## ADDENDUM

**PROJECT:** University of South Dakota  
Pardee Lab - SEM  
Vermillion, South Dakota

AD-1

**DATE ISSUED:** Thursday, November 6, 2014

**2** Partial Reflected Ceiling Plan  
 Scale: 1/4" = 1'-0"

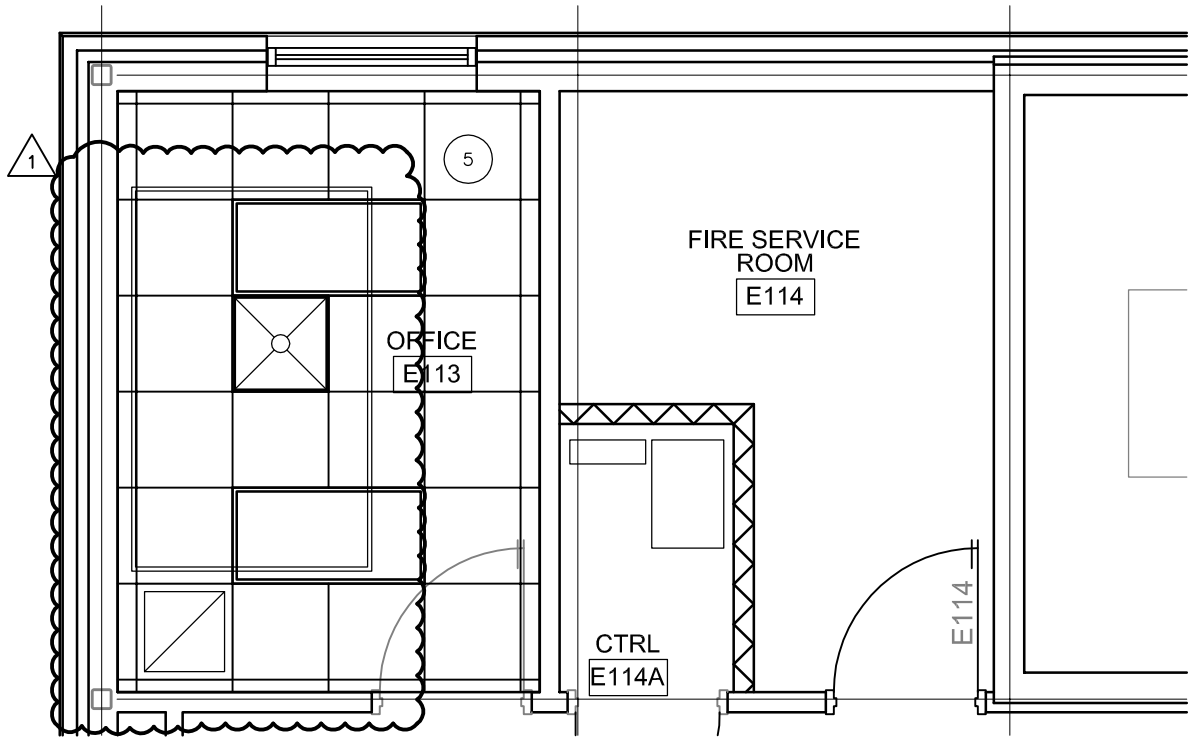
In reference to Sheet A-102, Detail 2, change to Detail 2 as shown on attached Supplemental Drawing A-102.1.
